Access Compliance Report

Public Rights-of-Way

(Curb Ramps)

| Intersection ID: 54217 | Main Street: GOLF_LINKS_DR | Cross Street: MIDWAY_PARK_DR | Location: SE |

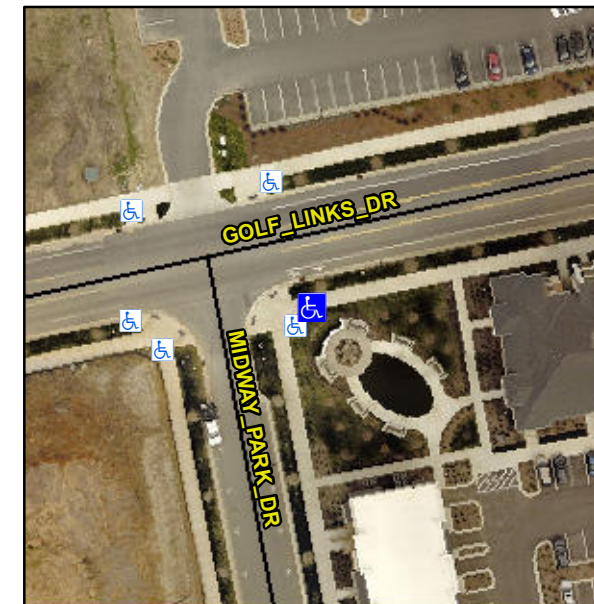
| ADA ID: 4791FFDD906F | Ramp Type: Perp | Initial Pass/Fail: Fail | Overall Compliance: No |

Not Found, R304.5.3

| Compliance | Description | Data | Compliance | Description | Data |
|------------|-----------------------|-------|------------|-----------------------------|------|
| Yes | Ramp Width (in) | 61.0 | No | Ramp XSlope (%) | 5.5 |

Remove & Replace Entire Ramp.
